SUBJECT: Forwards response to 980413 RAI re TS change 95-03,
addressing newly installed MSLB protection circuitry.

Subject: Oconee Nuclear Station
Docket Nos. 50-269, -270, -287
Proposed Revision to Technical Specifications
Technical Specification Change # 95-03
Response to Request for Additional Information #3

RESPONSE TO REQUEST FOR ADDITIONAL INFORMATION

Figure 1
Oconee Steam Line Break With Continued MFW Addition: Containment Pressure

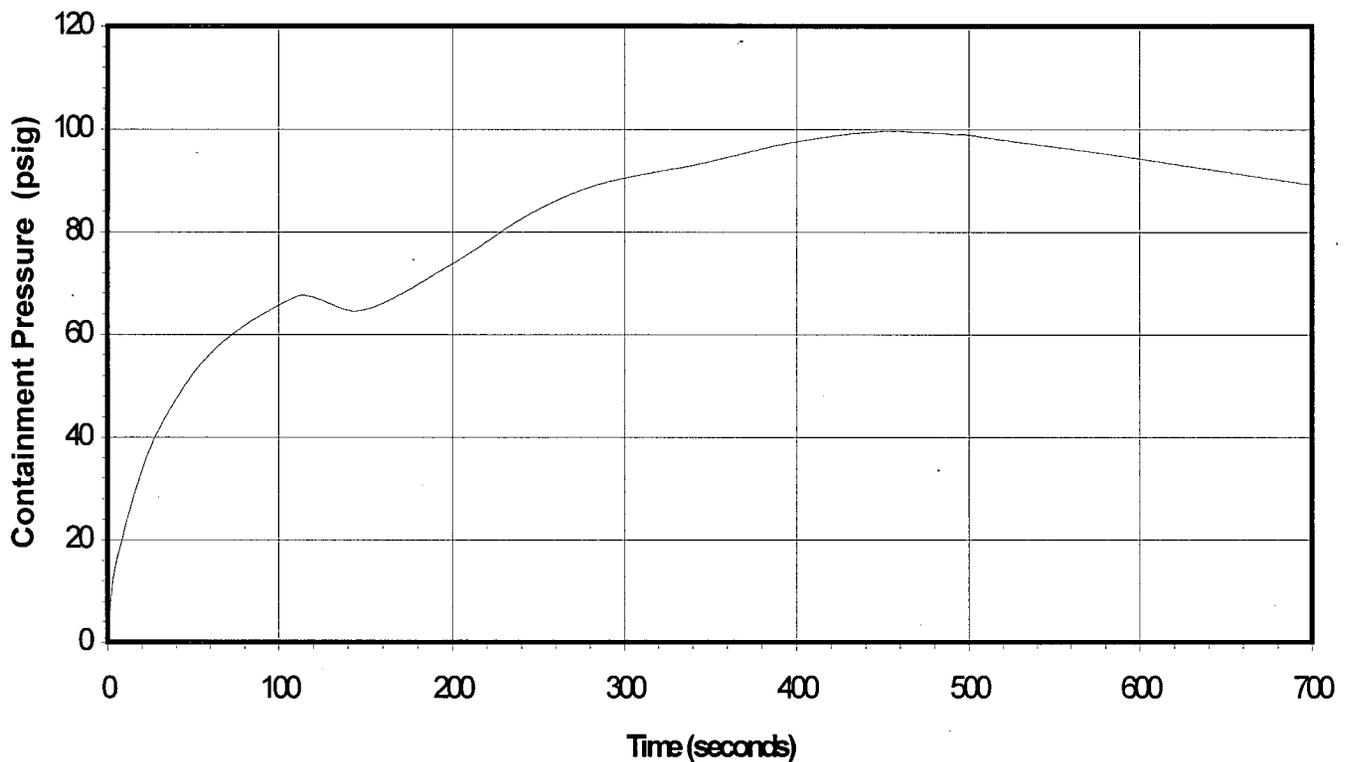
Provide the results of a containment analysis (as requested by Bulletin 80-04) that reflects the actual design of the MFW isolation capability at Oconee. The analysis should assume that feedwater continues to be added to the faulted steam generator (via the condensate pumps) for ten minutes (assumed for operator action to secure flow) or for the time it takes to isolate MFW flow via the MFW block valves if they can close under the differential pressure associated with the condensate pumps. The analysis can take credit for all containment cooling features, since no other single failures need be assumed. The analysis should also assume that offsite power is available since the condensate pumps would not be running for a loss of offsite power.

An analysis was performed for a main steam line break (MSLB) with continued feedwater addition to the faulted steam generator via the condensate booster pumps for ten minutes due to the failure of the main feedwater (MFW) control valve to close. The MFW block valves are assumed to be unable to close under the differential pressure associated with the condensate pumps. It is assumed that the MSLB Detection and Feedwater Isolation System functions to trip the MFW pumps and the turbine-driven emergency feedwater (EFW) pump, and to close the MFW control valve to the unaffected steam generator. Since a failure of the MFW control valve to the affected steam generator is assumed, no other single failure is postulated. Thus, two trains of high pressure injection (HPI) are credited and the EFW flowrate is controlled to maintain steam generator level at the control setpoint. Credit is taken in the analysis for all containment cooling features. Offsite power remains available.

The methodology used to perform the FATHOMS containment analysis is detailed in topical report DPC-NE-3003-PA, "Mass and Energy Release and Containment Response Methodology." Three reactor building cooling units (RBCUs) and two spray trains are assumed to be available. The RBCU actuation signal occurs at 2 seconds, and the units are running at 80 seconds. The containment spray actuation signal occurs at 17 seconds, and the spray flow starts at 109 seconds. Containment pressure increases steadily until the peak containment pressure (Figure 1) of 100 psig is reached at 445 seconds. The containment pressurization is terminated by the decreasing break flowrate as well as the change in the break flow from steam to liquid. The simulation is run for 700 seconds.

Duke performed a containment analysis to allow the NRC staff to assess the design of the MFW isolation capability at Oconee. The analysis assumed that feedwater continued to be added to the faulted steam generator, via the condensate pumps, for ten minutes. The analysis took credit for all containment cooling features since no other single failures were assumed. The analysis also assumed that offsite power was available. The analysis indicated that a peak reactor building pressure of 100 psig is reached at 445 seconds into the accident simulation. The containment temperature exceeded the equipment qualification limit during the 700 second transient simulation. However, this requested analysis is considered to be outside Oconee's current licensing basis. UFSAR Chapter 6 describes Oconee's current limiting MSLB analysis with respect to containment temperature and pressure.

INSTRUMENT DETAILS
 MAIN FDW VALVE CONTROL
 IFDW-32 & IFDW-4

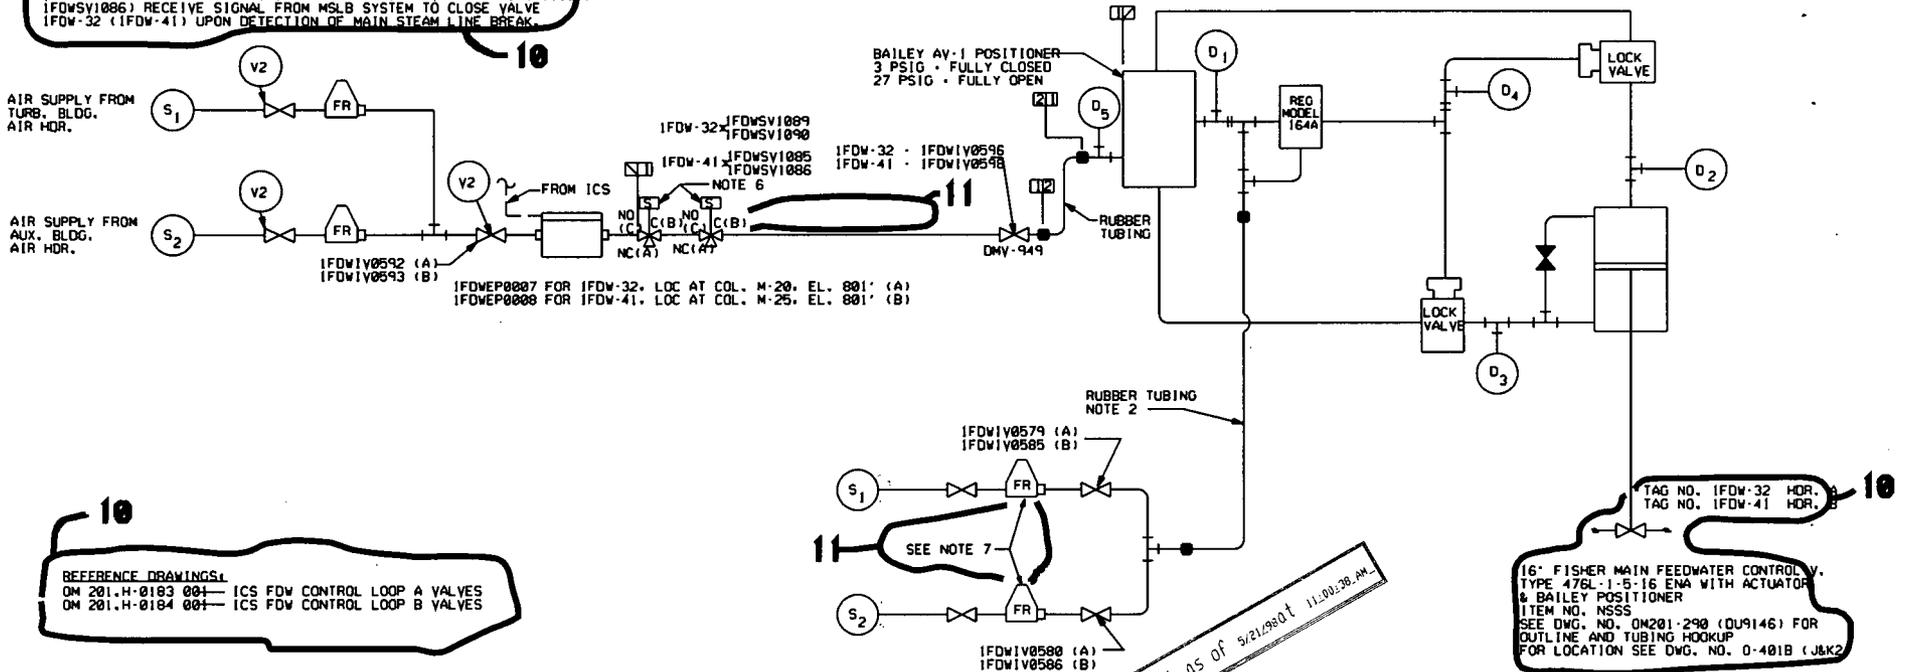
Identify all of the single active failures that could cause a MFW control valve not to go closed following an MSLB actuation signal; e.g., loss of power, loss of air, failure of the actuation circuitry, failures in the integrated control system, etc.

For normal operation under the Integrated Control System (ICS), the MFW control valves receive an instrument signal (3-27 psig) from E/P # 1FDWEP0007 or 8. This signal goes to the Bailey positioner on the valve. The positioner interprets the signal to open, modulate, or close the valve via the actuator. If supply air is lost, the trip lock valves will lock the actuator in the last controlled position. Each actuator is equipped with a manual handwheel to close the valve if required. See the attached instrument detail.

The MSLB circuitry that closes the MFW control valve is comprised of two solenoid valves, one per each train of MSLB, in series between the electric/pneumatic (E/P) converter and the pneumatic MFW control valve positioner. Upon a MSLB actuation either or both of these solenoids will energize which vents the pneumatic signal going to the pneumatic MFW valve positioner. When the pneumatic signal is vented, the valve closes. The MSLB initiating components (solenoids) are downstream of the ICS component (E/P). A single failure in the ICS will not affect the operation of the MSLB circuitry. The circuitry and instrumentation of the MSLB is powered from two separate vital power panel boards. Therefore, no single active failure to the electrical/electronic controls would cause a MFW control valve not to go closed following a MSLB actuation.

- A rupture of the supply air tubing to the positioner would result in the actuator not being able to close the valve.
- A rupture of the air output tubing from the positioner to the upper chamber of the actuator would result in the actuator not being able to close the valve.

- A failure of the valve positioner could cause the valve to fail as-is, open, or close.
- If the actuator stem to valve stem coupling fell off, then the actuator would not be capable of fully closing the valve.
